#### **1. KEFORD COLLISION AND TOWING JSP 18-31**

Public hearing at the request of Keford Collision & Towing for Planning Commission's approval of the Preliminary site plan, Wetland permit, and Storm water management plan. The subject property is currently zoned I-2 (General Industrial) with an associated Planned Rezoning Overlay (PRO) Agreement. The subject property is approximately 7.61 acres and is located on the south side of Grand River Avenue between Taft Road and Novi Road in Section 15. The applicant proposes to use the existing building for an auto body collision repair shop along with an accessory use of car rental services and to install an enclosed storage yard in the rear yard for towed vehicles of up to 160 spaces.

**Planning Review**  
 Keford Collision & Towing  
 JSP 18-31

**Figure 1.** City of Novi Regulated Wetland & Woodland Map (approximate parcel boundary shown in red). Regulated Woodland areas are shown in green and Regulated Wetland areas are shown in blue.

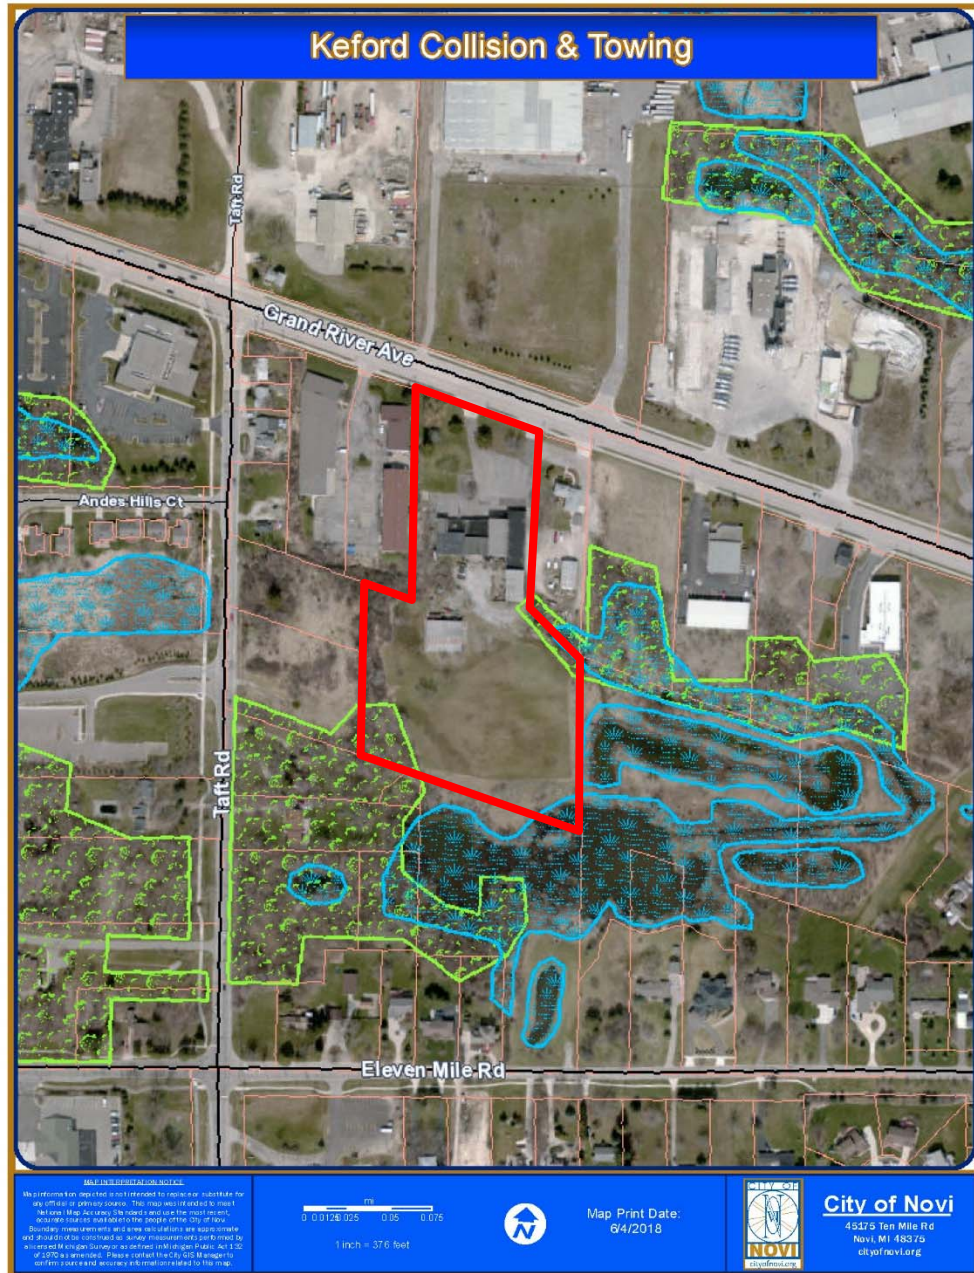
Based on our review of the application, Novi aerial photos, Novi GIS, the City of Novi Official Wetlands and Woodlands Maps (see Figure 1, attached), and our wetland verification site inspection conducted on July 25, 2018 it appears as if this proposed project site contains three (3) areas of on-site wetlands.

Environmental Consulting & Technology, Inc. (ECT) conducted a wetland evaluation for the proposed project site on July 25, 2018. ECT's in-office review of available materials included the City of Novi Regulated Wetland and Watercourse map (see Figure 1), USGS topographic quadrangle map, NRCS soils
